## HKPS Undervoltage Circuit Bypass

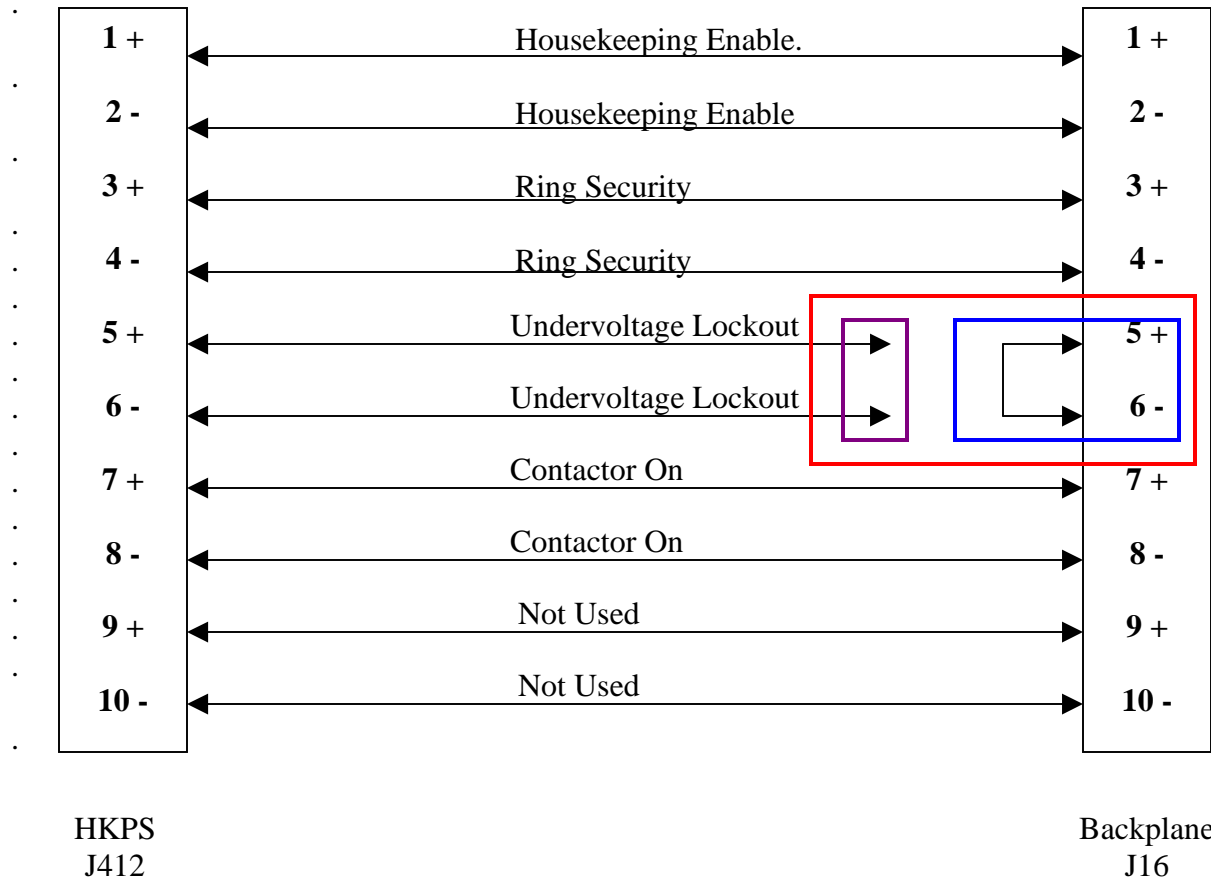
- 1) Remove wires from J16-5 and J16-6
- 2) Do not cut crimp pins off but rather securely Tape Pins for possible later use
- 3) Install a Jumper into J16-5 to J16-6
